From: Lok, Jasmine <jasmine.lok@sg.gaig.com>
Sent: Friday, 3 March 2023 2:24 PM
To: Renee Sia (LKK Auto)
Cc: SUR
Subject: Survey Report & Invoice of Vehicle SMD 760P Ref: CLMOMVP000001290
Attachments: GAI-LKKInvoice-AC2301256.pdf; GIA RPT.pdf; LKKAdjustment.pdf; LKKInspection.pdf; LKKPhoto.pdf; Resurvey Photo-1.pdf; SUPPLEMENTARY.pdf

ADJUSTMENT ON REPAIR COST FOR VEHICLE NO. SMD 760P

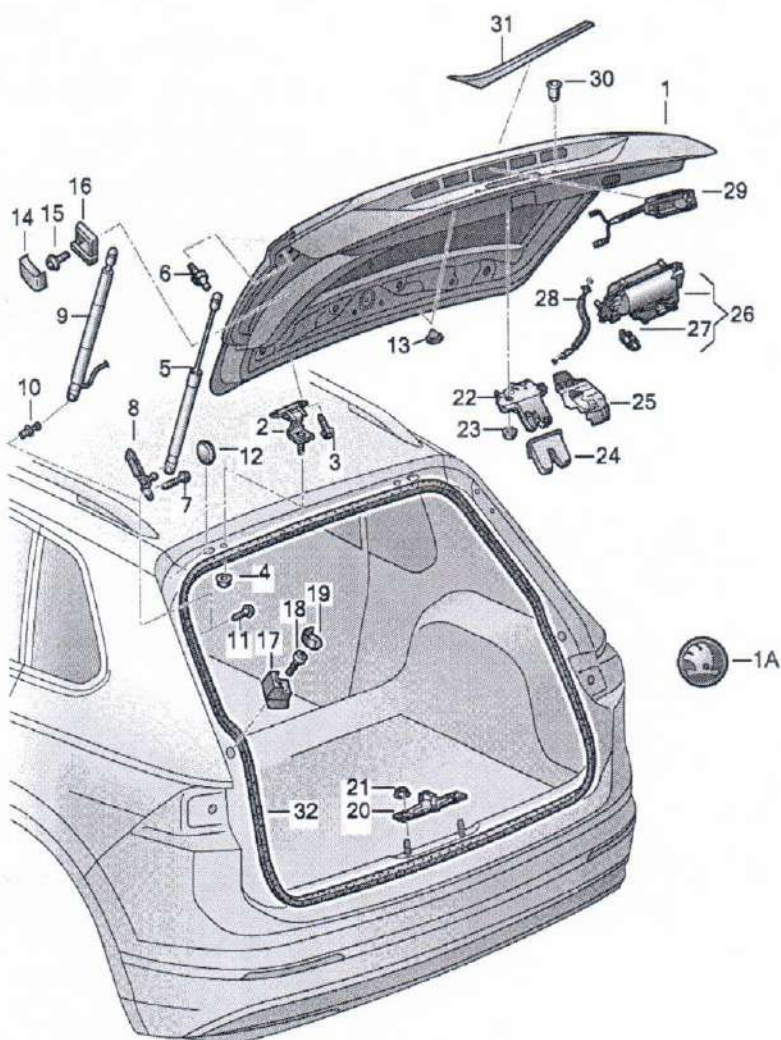
- 1) UNBEKANNT REAR BOOT LID *necessary item must replace* 8880
- 2) HIGH-MOUNT 3RD BRAKELIGHT *- see (must replace) which can remove required to be replaced*
- 3) COVER FOR REAR BUMPER (LOWER) *at 8896 & 8897*

1.) _____ is the new boot lid. See photo below.
0414.

2.) _____ - this is a necessary item when boot lid
is replaced because it is glued into
the new boot lid and once removed, the
moulding will break. See photo below
0427, 0430
